Device TC1797
Marking/Step QS-AC
Package P/PG-BGA-416-10

01961AERRA

This Errata Sheet describes the deviations from the current user documentation.

FADC_TC.005 Equidistant multiple channel-timers

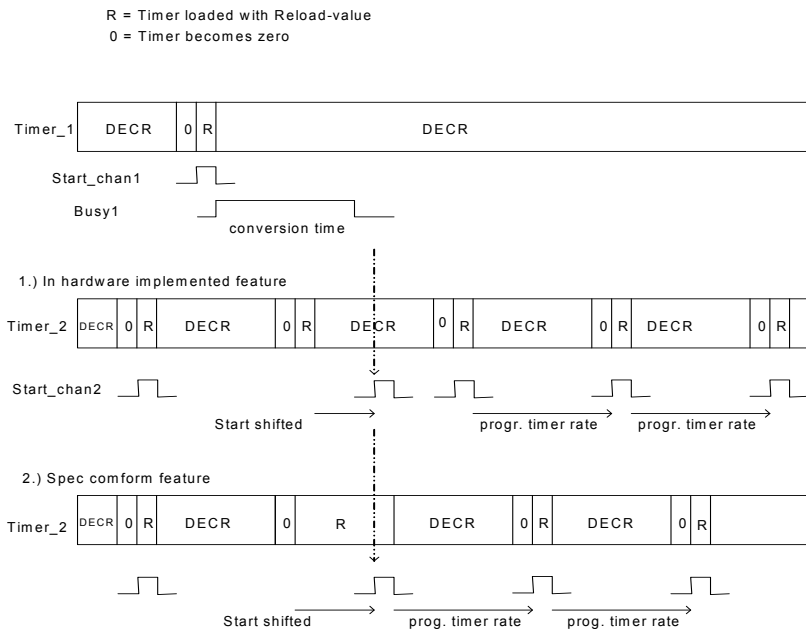
The description is an example for timer_1 and timer_2, but can also affect all other combinations of timers.

Timer_1 and Timer_2 are running with different reload-values. Both timers should start conversions with the requirement of equidistant timing.

The correct behavior would be a reload when the requested conversion (of channel_2) is started.

Therefore the start of conversion for channel_2 is delayed by maximum one conversion-time. After this delay it will be continued with equidistant conversion-starts. Please refer to the following figure.

Figure 2 The second frame starts in the same slot

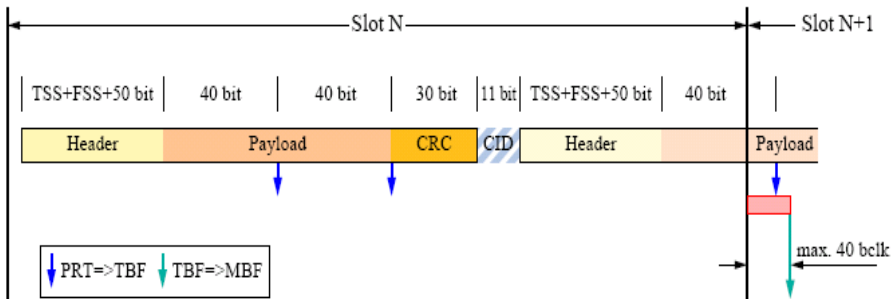
Scope:

The erratum is limited to cases where the complete header and a part of the payload of another frame is received in slot N.

Figure 3 Loss of Arbitration

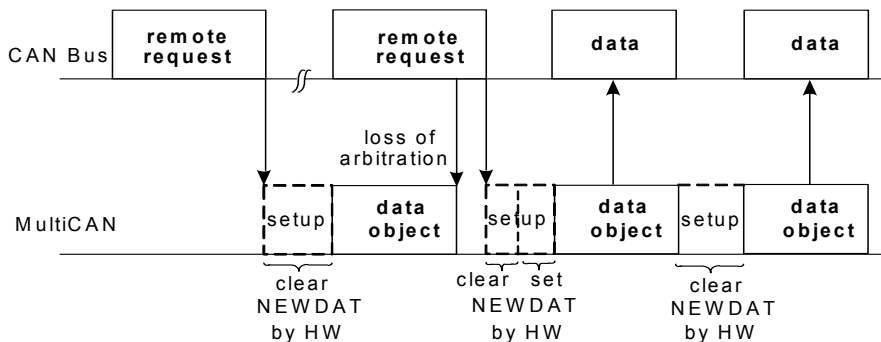
When the appropriate message object (data frame) triggered by the first remote frame wins the arbitration, it will be sent out and `NEWDAT` is not reset. This leads to an additional data frame, that will be sent by this message object (clearing `NEWDAT`).

There will, however, not be more data frames than there are corresponding remote requests.
